TRANSMITTAL OF EIGHTH TAAG REPORT - Hmb-173-84

DRAFT
EIGHTH REPORT
OF THE
Technical Assistance and Advisory Group (TAAG)

Three Mile Island Unit 2 (TMI-2)
For the Period December 1, 1983, to April 1, 1984

LONG HANDLED TOOL DEFUELING CONCEPT
 OVERALL LAYOUT

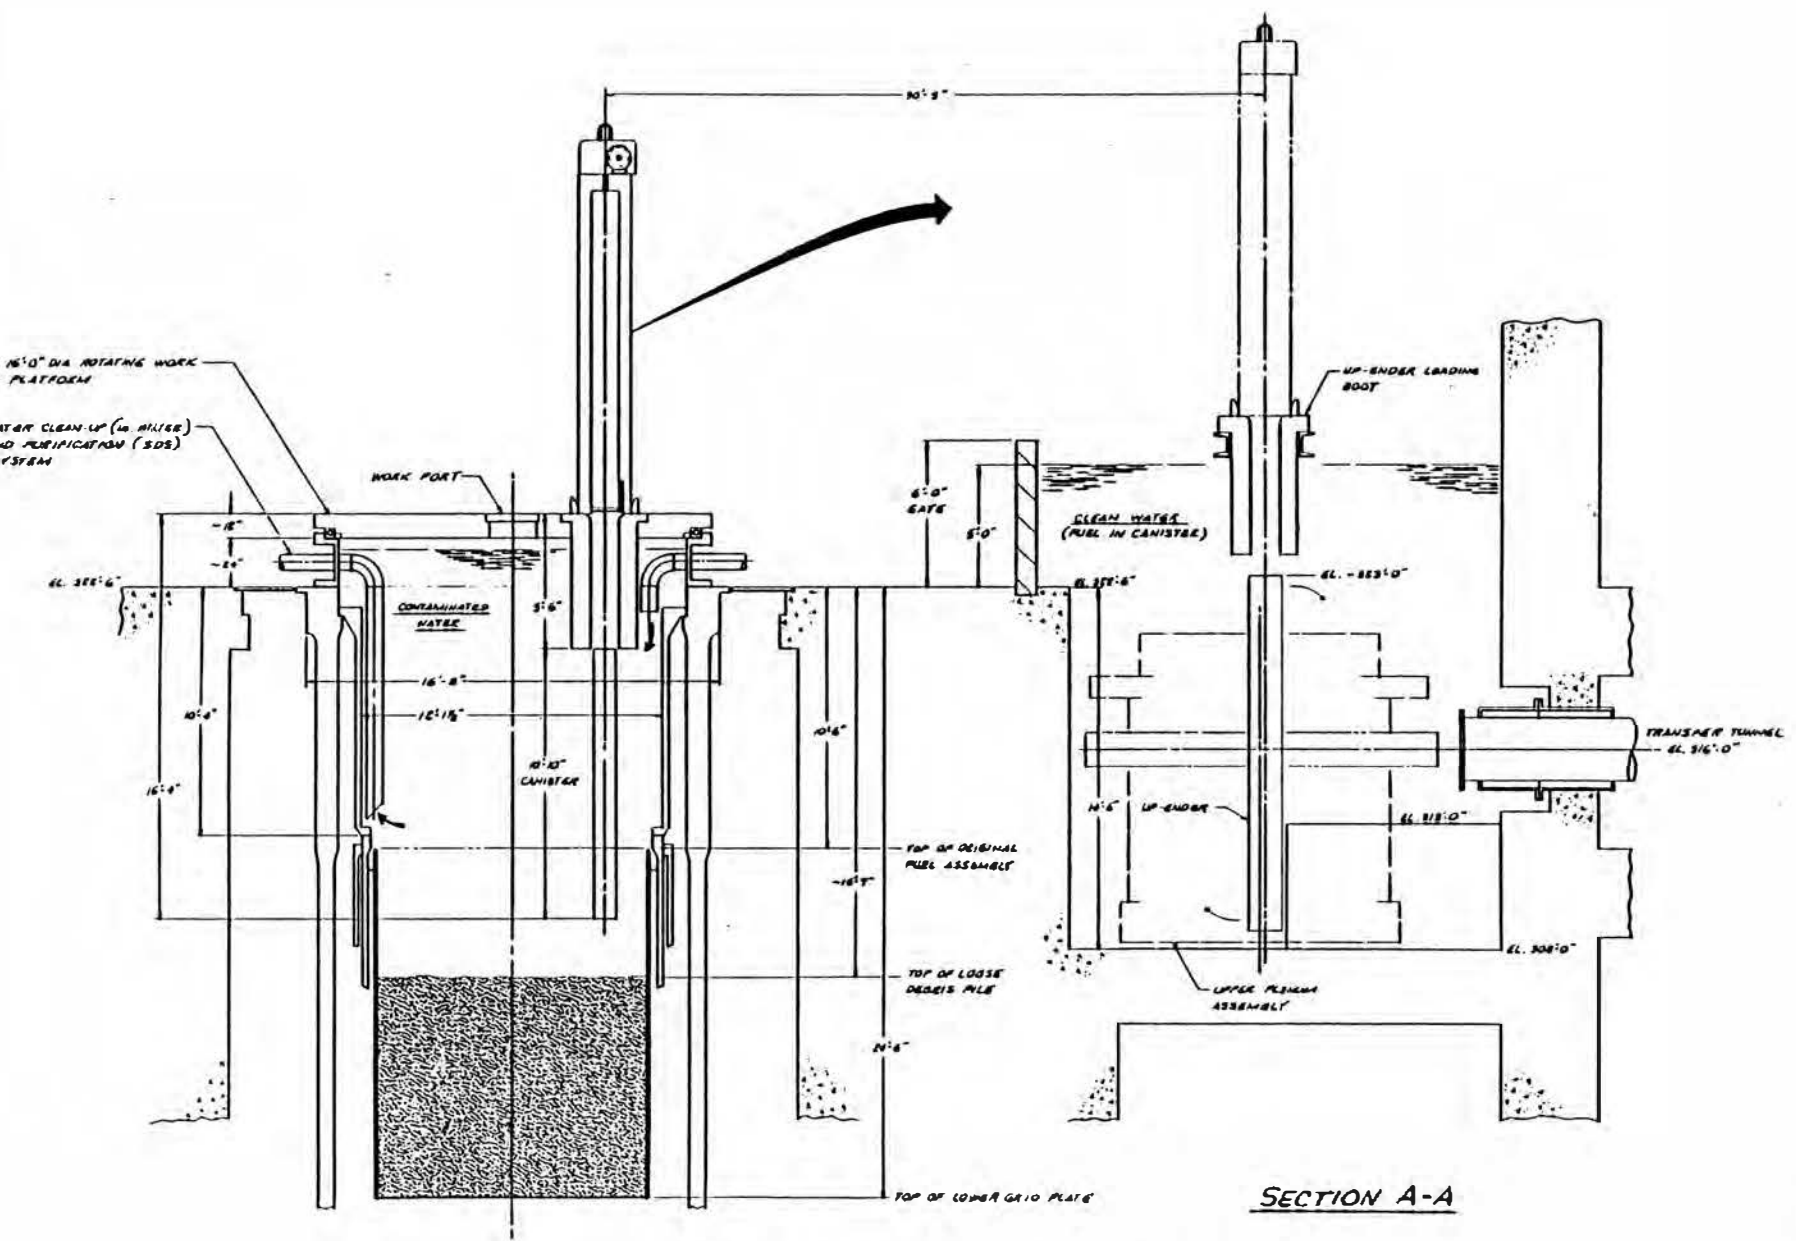
To provide adequate water shielding for the operations that take place in the deep end of the reactor cavity pit and in the spent fuel pool, it would appear that a 4 to 6 foot gate needs to be installed to allow the water level in the deep end of the reactor cavity and the spent fuel pit to be raised above the elevation of the reactor vessel flange. Once the fuel canister is transferred out of the reactor building and into the spent fuel building, it is removed from the plant's existing horizontal fuel transfer system by means of a transfer boot and simple cask to deposit the canister in an appropriate storage rack location. The overall layout of this concept and key features are shown in Figures 1 and 2.

tion. Accordingly, only the gate itself needs to be provided. The water level behind this gate is basically set by the water level over the spent fuel racks in the auxiliary fuel handling building (see Figure 1). Since the deep end of the reactor cavity and the spent fuel pool are connected by the transfer tubes, the water levels in these two pools will be at the same level. The water level shown in Figures 1 and 2 also provides adequate shielding for the storage of the upper plenum assembly and provides sufficient water over the "up-enders" to allow the transfer and handling of canisters. A detailed analysis of the concept may allow further reduction of this water level by a foot or so, but at this point, it is not desirable to reduce the margin in this area. In any case, this gate size and water depth appear to be reasonable.

LONG HANDLED TOOL DEFUELING CONCEPT
 REACTOR CROSS SECTION

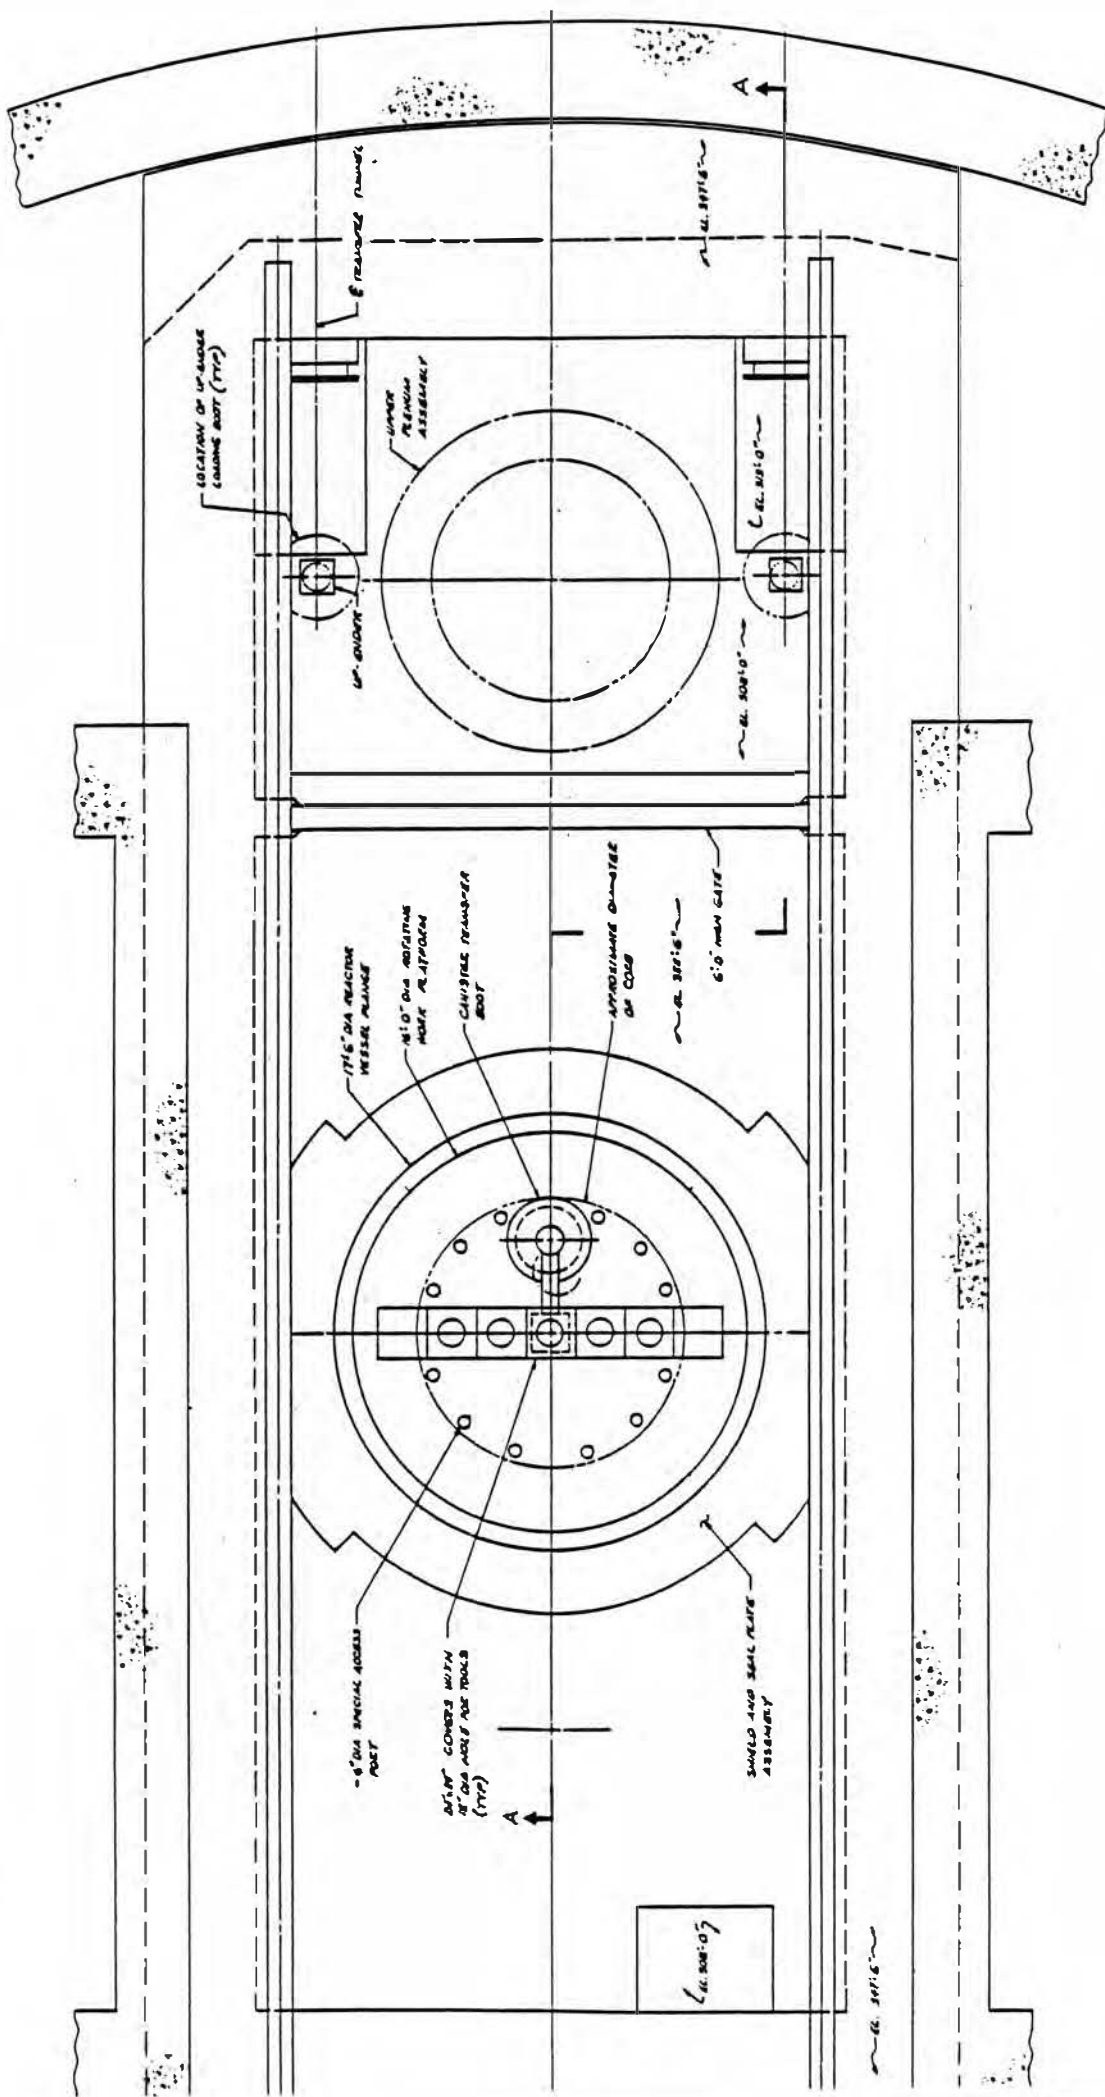
To transfer canisters loaded with fuel debris from the reactor vessel, a shielded transfer boot and a very simple transfer cask would be involved (see Figure 2). The shielded trans-

foot or so above the flange. As can be seen in Figure 2, with the shielded work platform approach, the working water depth to the top of the existing loose core debris pile is approximately 16 feet and the working depth all the way to the lower grid plate is only about 26 feet. Accordingly, this approach results in working water depths that are very practical for long handled tool defueling operations.

The shielded work platform is approximately 12" thick and is assumed to have no more than 3" of lead shielding (see Figures 2 and 3). The platform also includes a transfer boot as shown in Figure 2. The transfer boot has provisions for a lateral side gate which would allow long handled tools to move canisters or other objects between the slotted work area of the shielded platform and the center of the transfer boot without requiring lifting the canister out of the water. Likewise, the transfer boot at the "up-ender" would be similarly designed with a side opening gate. This concept of using transfer boots to move fuel between water and a transfer cask has been used extensively

The shielded working platform is positioned on an approximate 2 foot high dutchman that fastens directly to the reactor vessel flange (see Figure 2). This dutchman keeps the working water depth low, yet allows the necessary water purification system to draw water out and return the water to the reactor vessel. Likewise, this dutchman also allows an air sweep system to collect any gases that may evolve off during the defueling operations to be drawn off from the underside of the shield platform so as to minimize any airborne activity problems that may occur. This approach of air and water processing through the dutchman would not require activation of any of the systems currently attached to the reactor coolant system (e.g. decay heat removal, mini-decay heat removal, etc.), and therefore, may possibly help eliminate such systems from the plant's Tech. Specs. A conceptual layout of the dutchman is shown in Figure 12.

- a. As can be seen in Figure 2, there is a gate approximately 6 feet high installed between the reactor vessel and the deep end of the reactor cavity pit. The original plant construction included the necessary provisions in the cavity walls and floor for a gate slot at this loca-

- b. The handling of canisters in the deep end of the reactor cavity also involves the use of a transfer boot (e.g. mounted on a stand) over the "up-ender" of the fuel transfer mechanism. With this arrangement, the transfer cask moves back and forth between the reactor vessel transfer boot and the "up-ender" transfer boot (see Figure 2). Conceptually, this is not too different

CANISTER LOADING ELEVATIONS IN REACTOR VESSEL

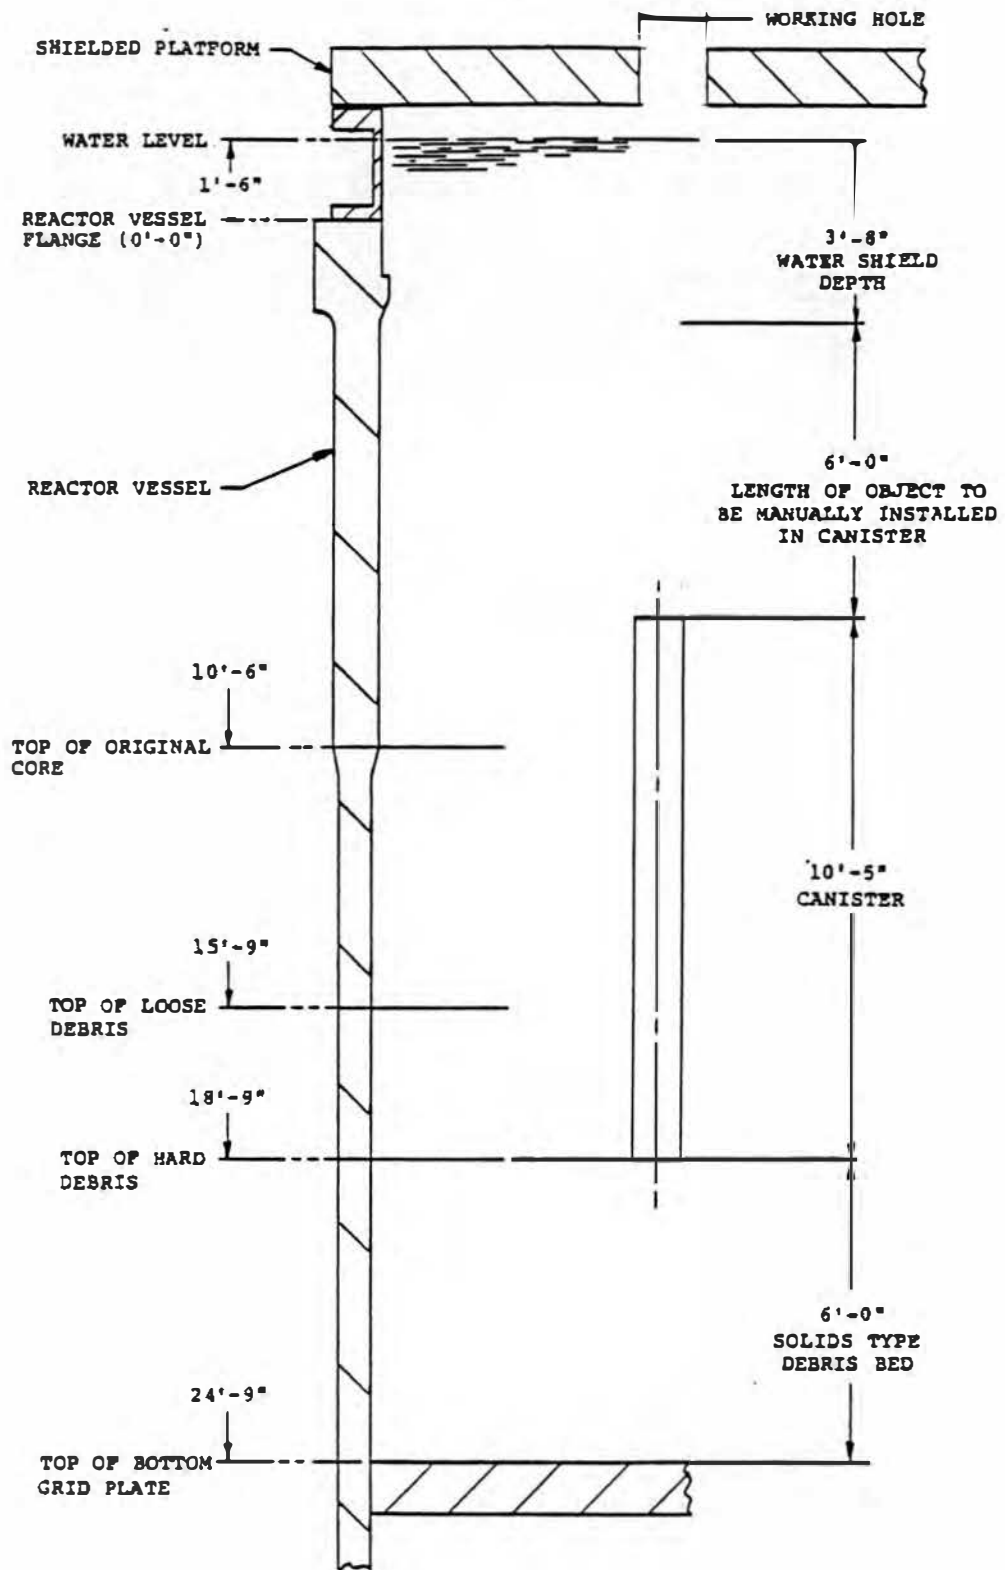
The water depths available in the reactor vessel when manually picking up and loading core debris objects (e.g. fuel rods, end-fittings) into canisters are shown in Figure 5. This figure is based on the assumption that the loose core debris has already been vacuumed into canisters.

As can be seen in Figure 5, a 6-foot long object can be loaded into a canister and there will still be 3'-8" of water available for shielding. This depth of water is more than adequate to make the dose to workers on the shielded platform very low. The radiation levels resulting from raising various objects near the water surface are discussed in Section II.C below.

DOSE FROM A FUEL CANNISTER DURING DEFUELING OPERATIONS

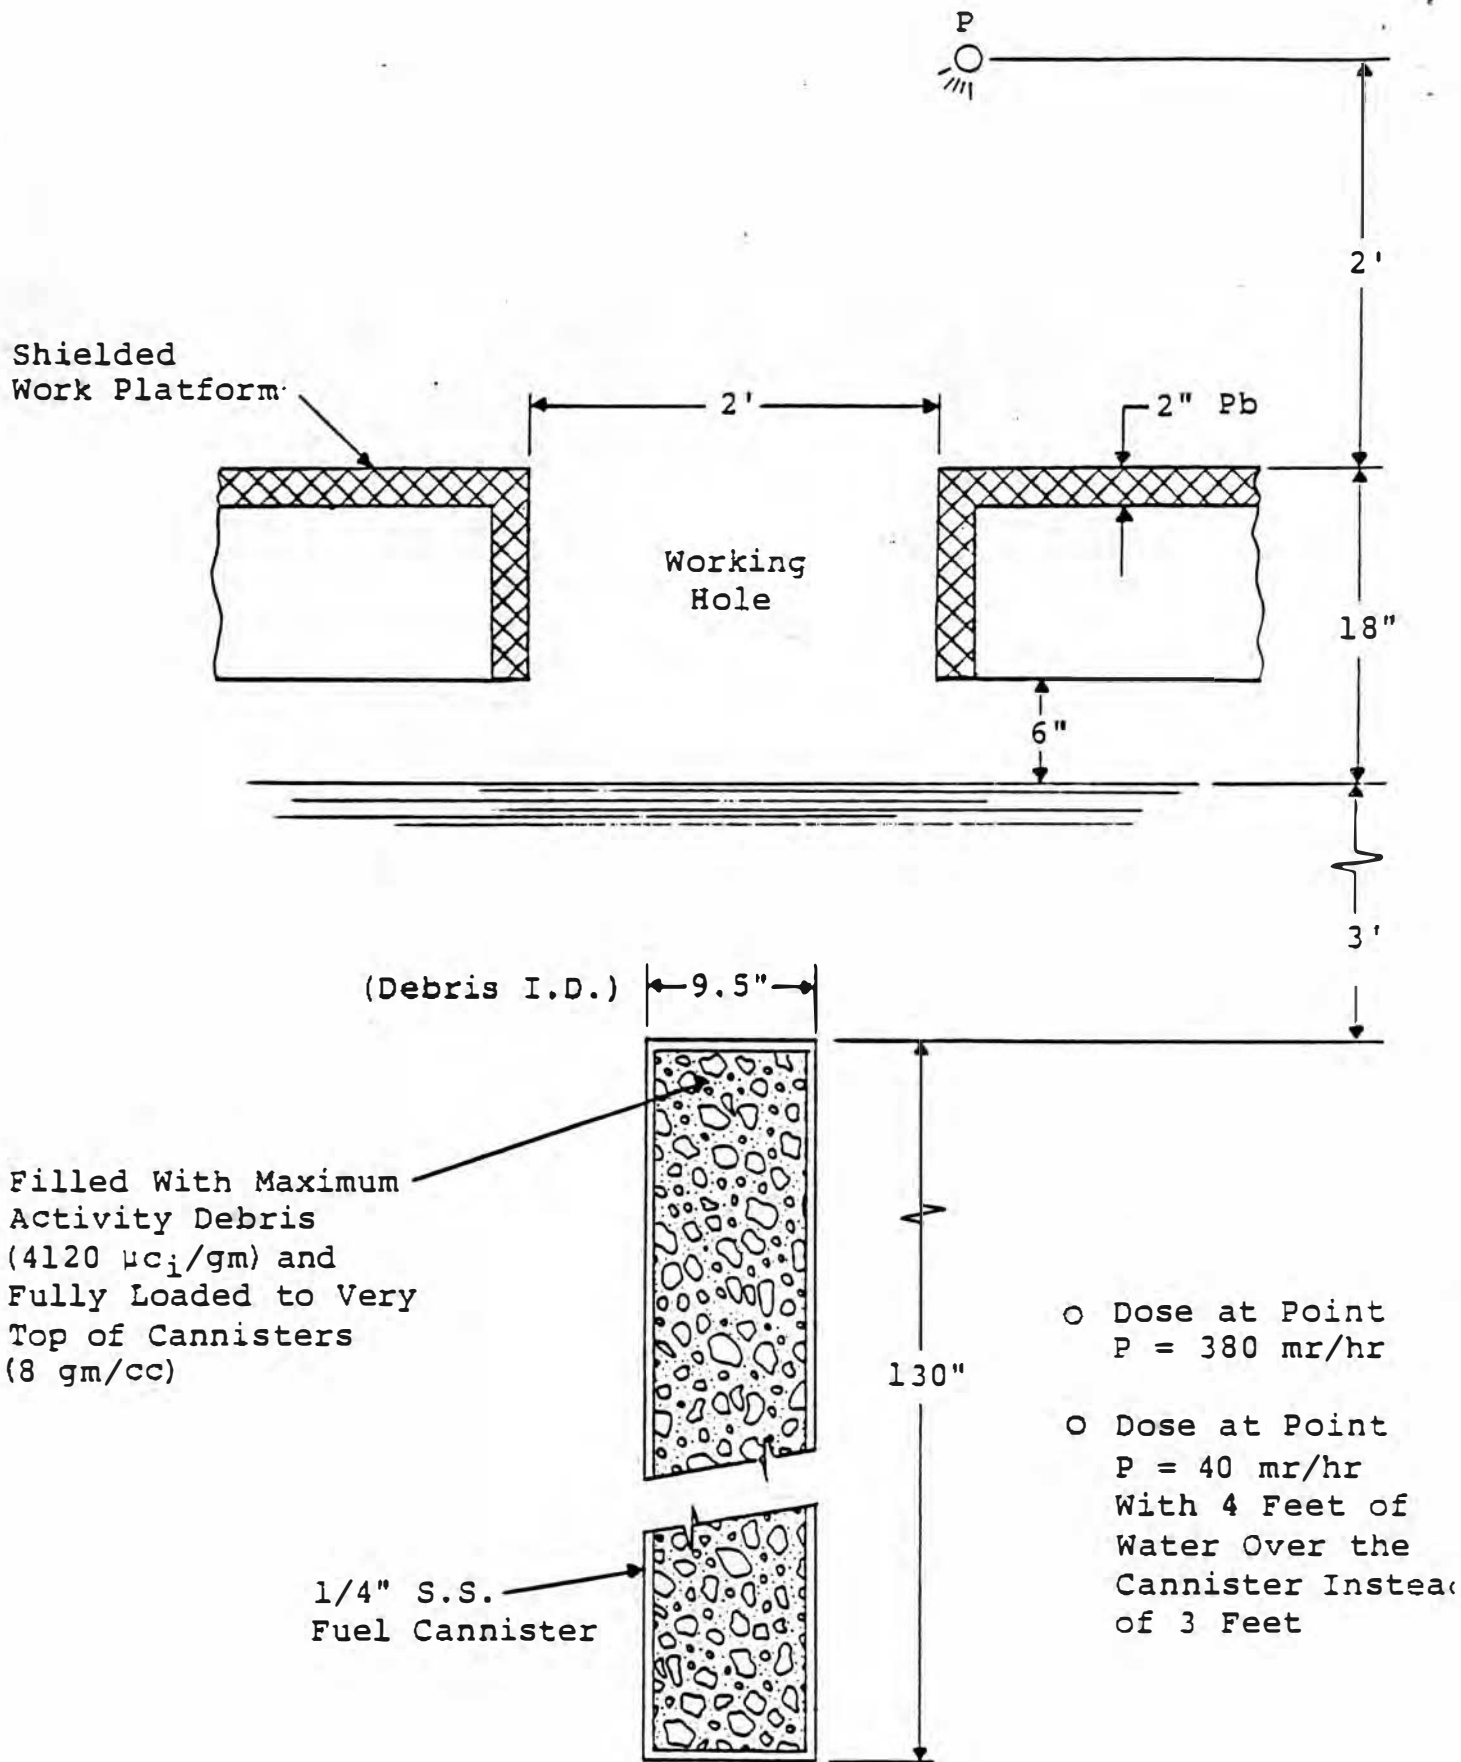
2. An assessment was made of the radiation level generated by a canister that was fully loaded with maximum activity debris (see Figure 6). As can be seen in this figure, even if such a very highly and fully loaded canister was brought to within 3 feet of the water surface, the radiation level at 2 feet above the shielded platform, assuming a 2-foot opening, would be about 380 mr/hr and about 40 mr/hr if the water depth is maintained at 4 feet. Accordingly, about 4 feet of water shielding should be quite adequate to permit handling of a canister.
